SHINE MEDICAL TECHNOLOGIES, INC.

SHINE MEDICAL TECHNOLOGIES, INC. APPLICATION FOR CONSTRUCTION PERMIT RESPONSE TO REQUEST FOR ADDITIONAL INFORMATION

CHAPTER 9 – AUXILIARY SYSTEMS

RAI 9a2.1-3

Figure 9a2.1-3-1: Preliminary RCA Ventilation System Flow Diagram
(Sheet 1 of 2)

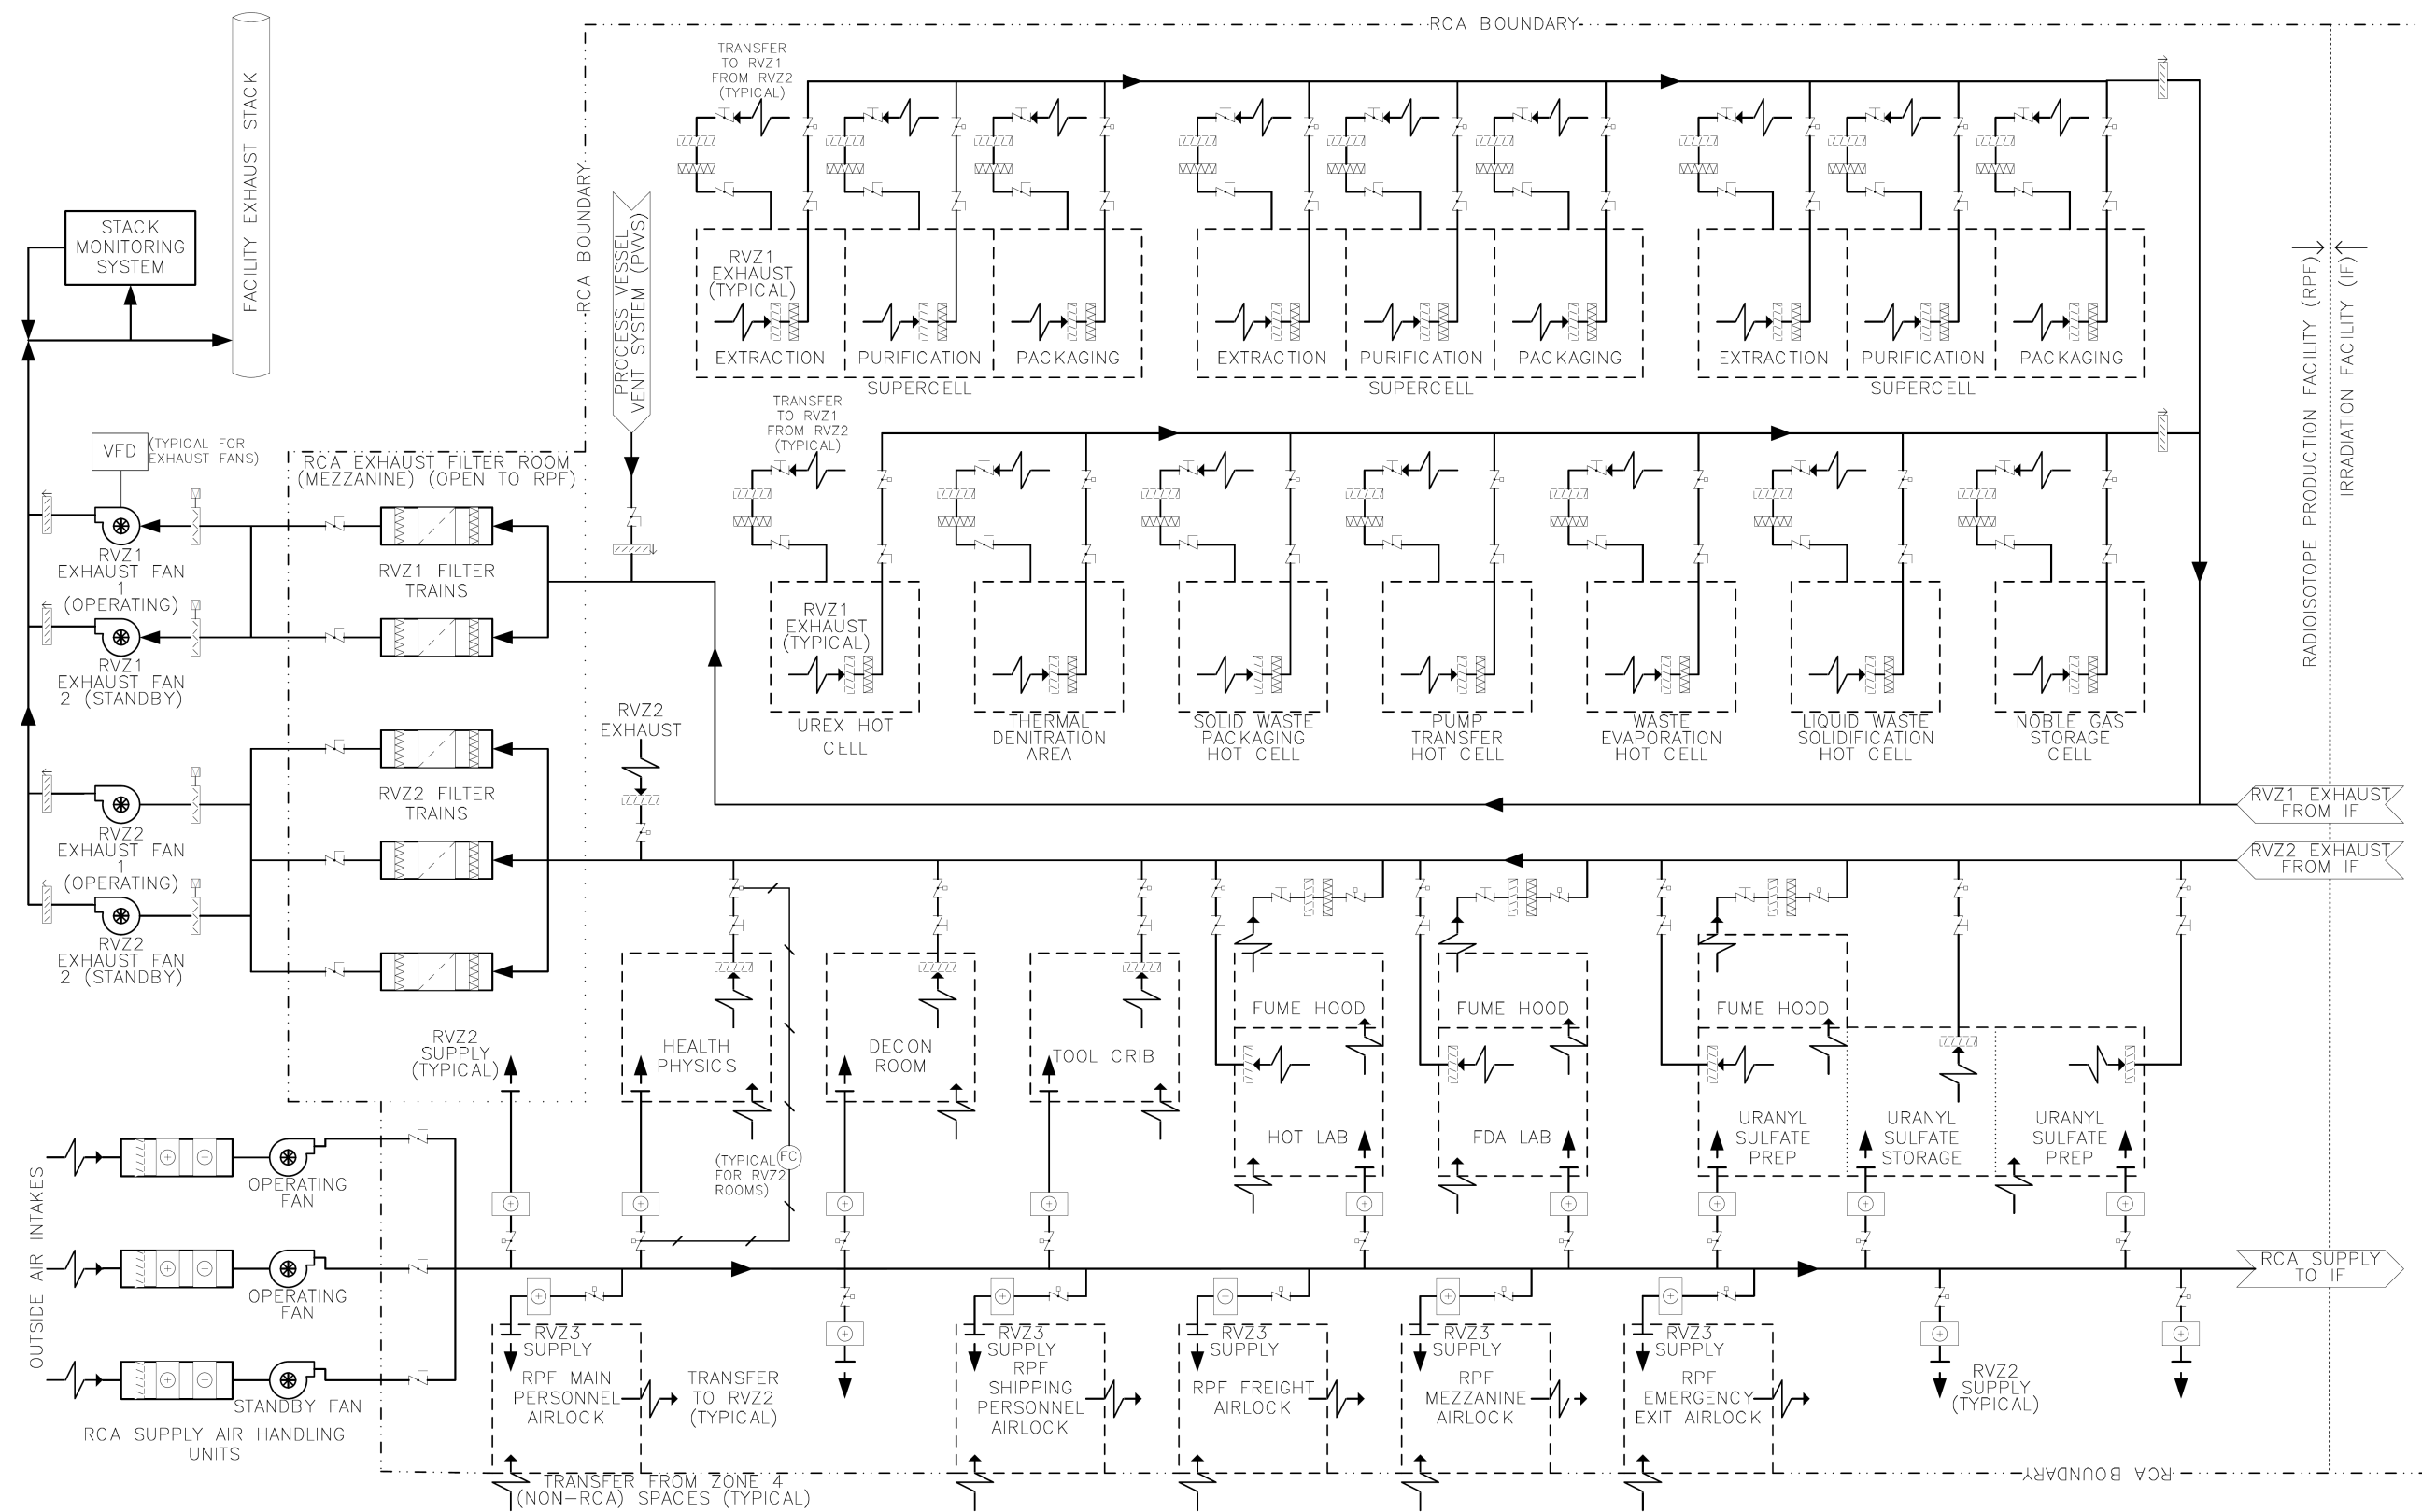
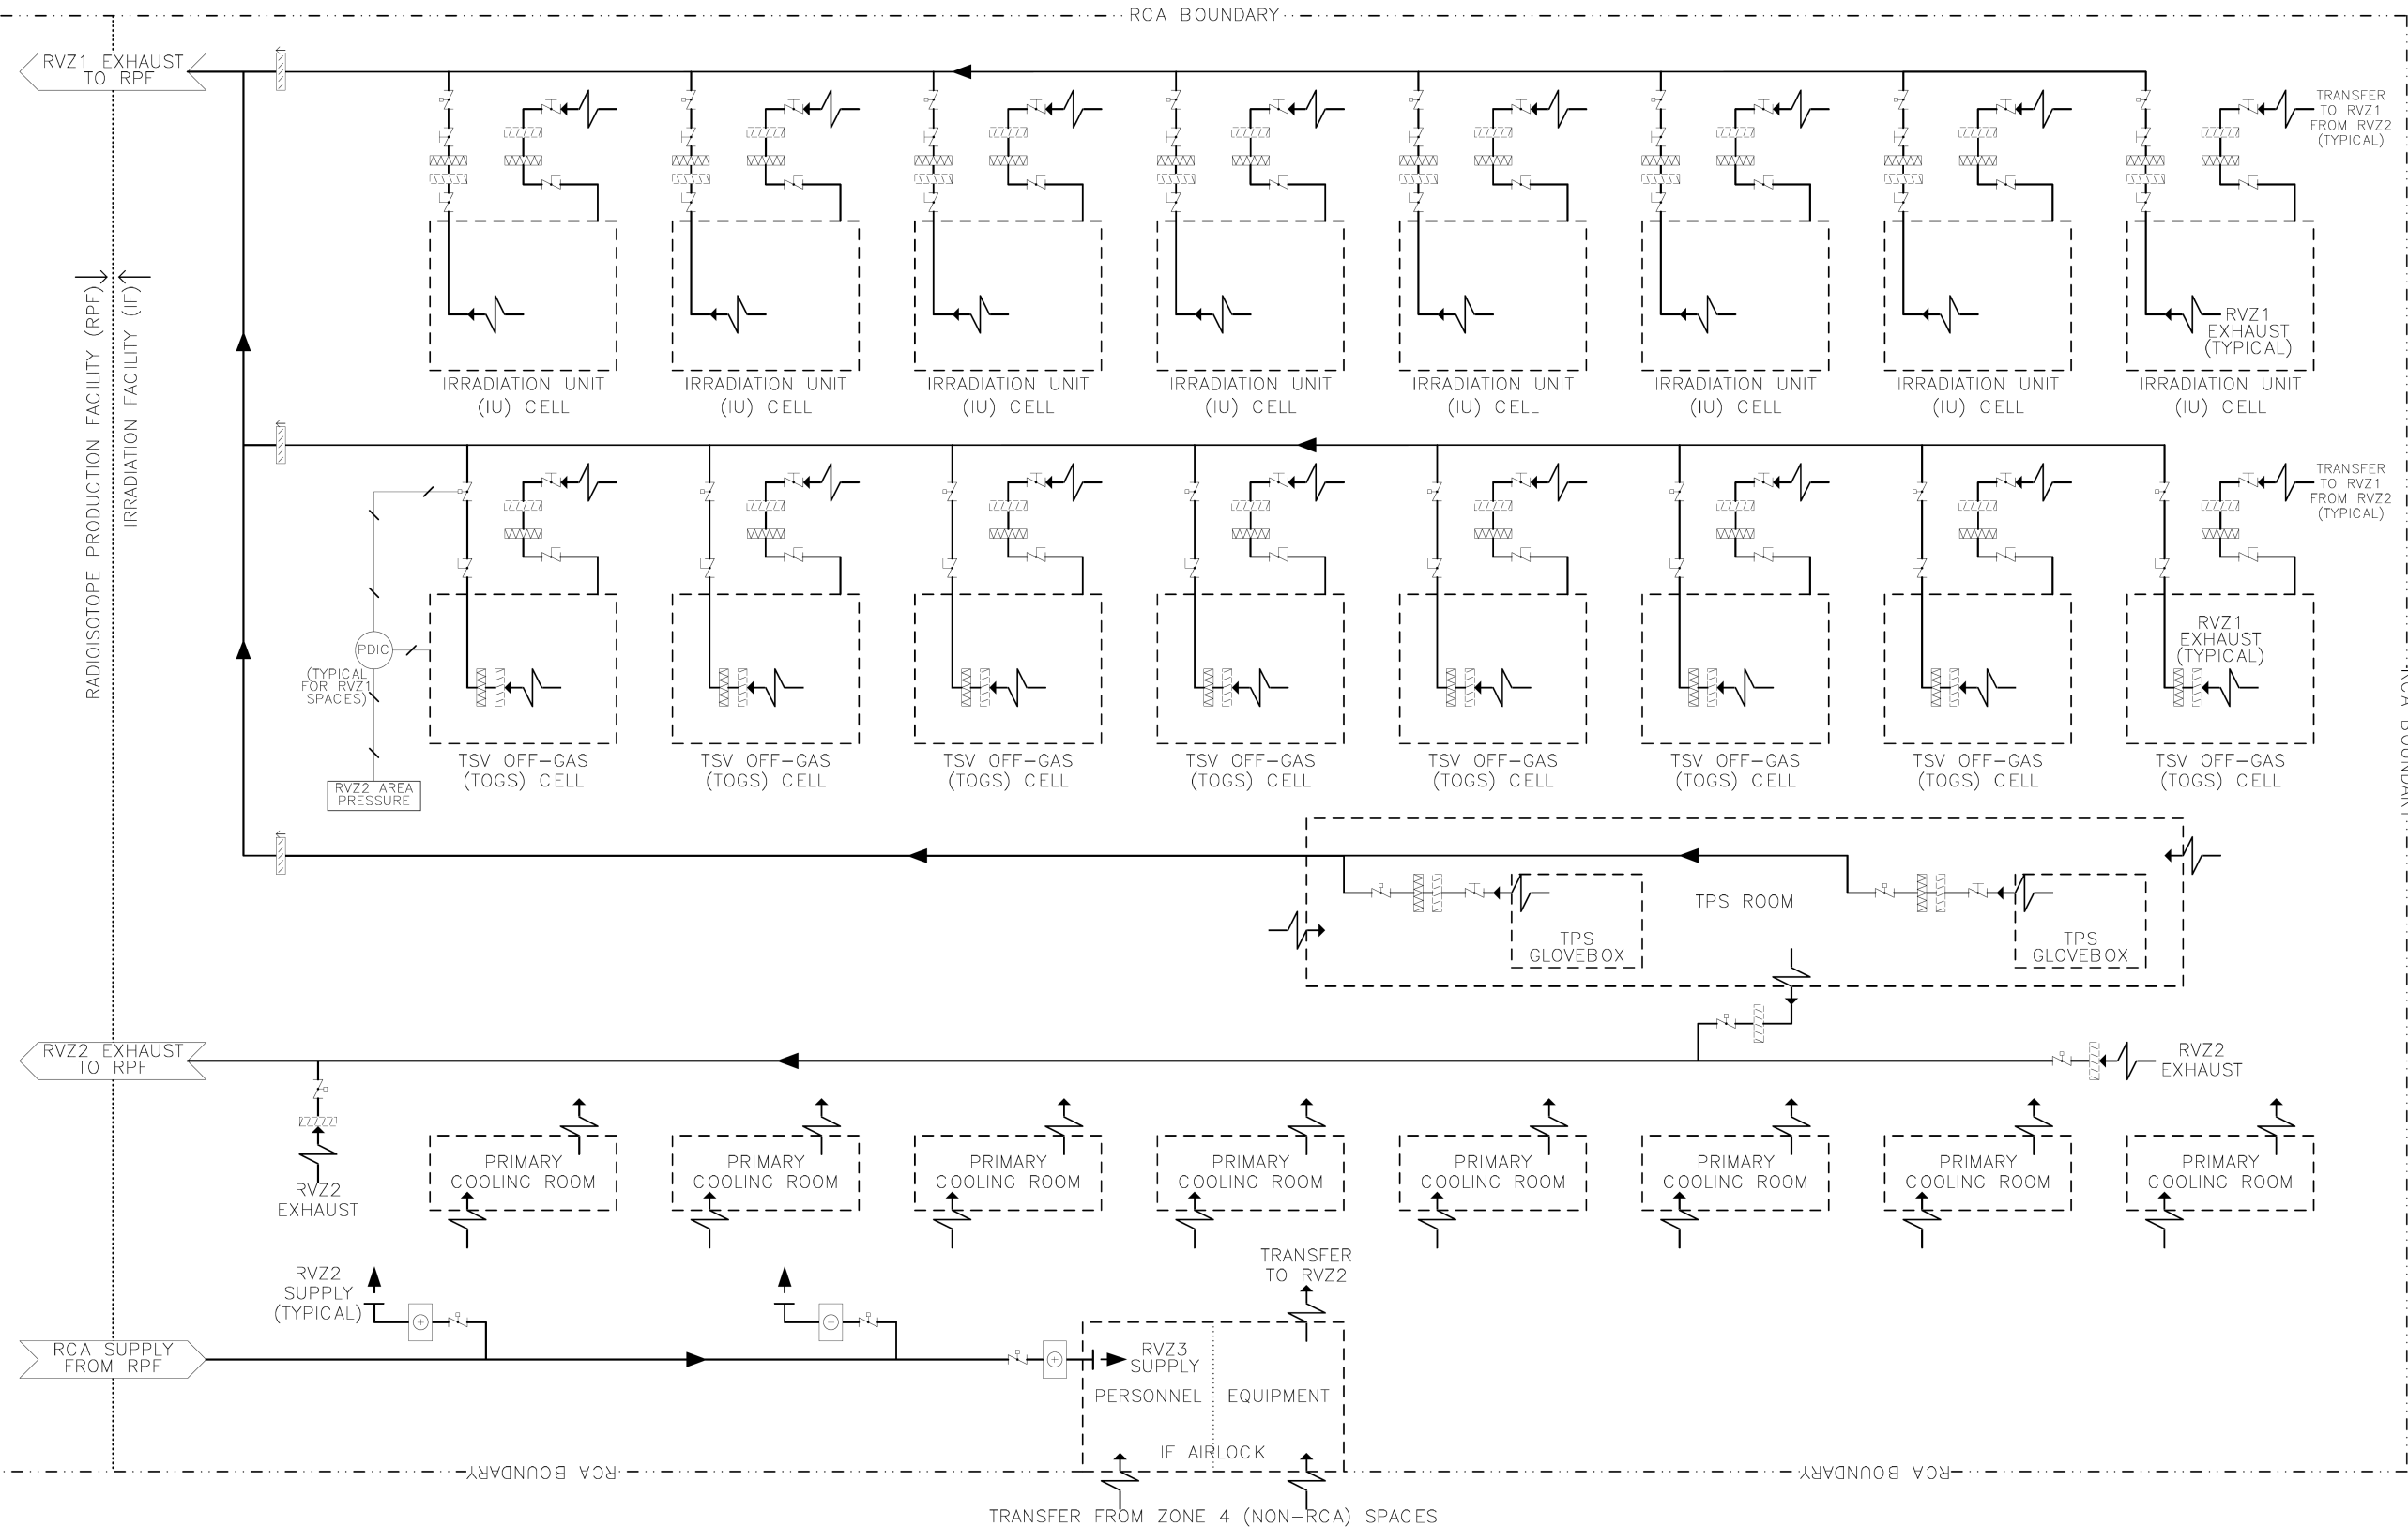
- a. *While SHINE provided information on the source of air supply for Radiological Controlled Area (RCA) Ventilation System Zone 1 (RVZ1), in response to RAI 9a2.1-1(a), PSAR Figures 9a2.1-1, "RVZ1 Ventilation Flow Diagram," and 9a2.1-2, "RVZ2SA and RVZ2 Ventilation Flow Diagram" were not revised. SHINE's response also did not clarify what areas/enclosures/rooms are considered RVZ1, RCA Ventilation System Zone 2 (RVZ2), and RCA Ventilation System Zone 3 (RVZ3). Additionally, a revised RVZ3 flow diagram was not provided as requested in RAI 9a2.1-1(b).*

- i. *Provide additional information stating what areas/enclosures/rooms are considered RVZ1, RVZ2, and RVZ3, as well as revised flow diagrams and descriptions for RVZ1, RVZ2, and RVZ3. Ensure consistency between figures and descriptions in the text of SHINE PSAR Section 9a2.1, "Heating Ventilation, and Air Conditioning Systems." Include a description and flow diagram for "Zone 4," as applicable.*

- b. *SHINE's response to RAI 9a2.1-1 discusses "RPF Airlocks" and an "IF Airlock" supplied by RVZ2 Supply Air. The response also states that "RVZ3 areas include the RCA airlocks." Additionally, Figure 9a2.1-2 shows two "Zone 3 Airlocks" and Figure 9a2.1-2-1, "Facility Ventilation Zone 4 Flow Diagram," shows an arrow to the "RPF Airlocks" and an arrow to the "Irradiation Facility Airlock." However, SHINE PSAR Figure 1.3-2, "SHINE General Arrangement" depicts the following airlocks:*

Provide additional information relating the discussion of airlocks in response to RAI 9a2.1-1, the airlocks shown in Figures 9a2.1-2 and 9a2.1-2-1, and the airlocks shown in Figure 1.3-2.

A preliminary flow diagram of the RV is provided in Figure 9a2.1-3-1. SHINE has revised the PSAR to replace the RVZ1 flow diagram, provided in Figure 9a2.1-1 of the PSAR, and the RCA Zone 2 Supply Air (RVZ2SA) and RVZ2 flow diagram, provided in Figure 9a2.1-2 of the PSAR, with the preliminary flow diagram of the RV provided in Figure 9a2.1-3-1. A mark-up of the PSAR changes is provided in Attachment 1. The non-public (proprietary) version of the PSAR, incorporating the changes provided in Attachment 1, is provided in Enclosure 3. The public (non-proprietary) version of the PSAR, incorporating the changes provided in Attachment 1, is provided in Enclosure 4.

The preliminary RV flow diagram, provided as Figure 9a2.1-3-1, includes the IF airlock and the five RPF airlocks. SHINE has replaced Figure 9a2.1-2 of the PSAR with Figure 9a2.1-3-1, as described in Part a(i) of this response.
